Addendum #3

Plumbing Renewal at Sainte-Jeanne-d'Arc

Arch ADDENDUM No. 2

Project	Plumbing Renewal At EEC Sainte Jeanne D'Arc	Date of Issue	Feb 4, 2021
Project No.	2003	File	7.1.03Addenda
Owner	Conseil scolaire catholique MonAvenir	Contract(s)	All contracts

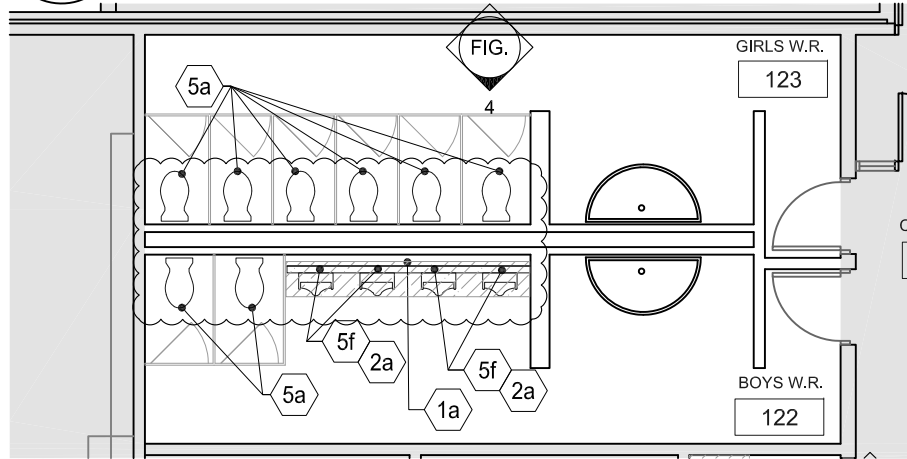
Question 3: Why are we changing the PFT just under the toilets in room 122 and 123? And we will have to take out portions to do that

1	PFT replacement at the toilets in rooms 122 and 123 is not required. Refer to revised dwg ADD-02
	Mech / Elec Clarifications by DEI
2	The bottle filling stations (BF-1) need 120v/1/60 power as part of the base bid. The alternate price for the electronic versions of L-1, L-2, DL-1 are for battery powered faucets that do not require 120v/1/60
3	Interference dwgs are not required for this project

Answer 3: PFT replacement at the toilets in rooms 122 and 123 is not required. Refer to 2003 Arch Addendum 02 attached, including the revised drawing ADD-02.
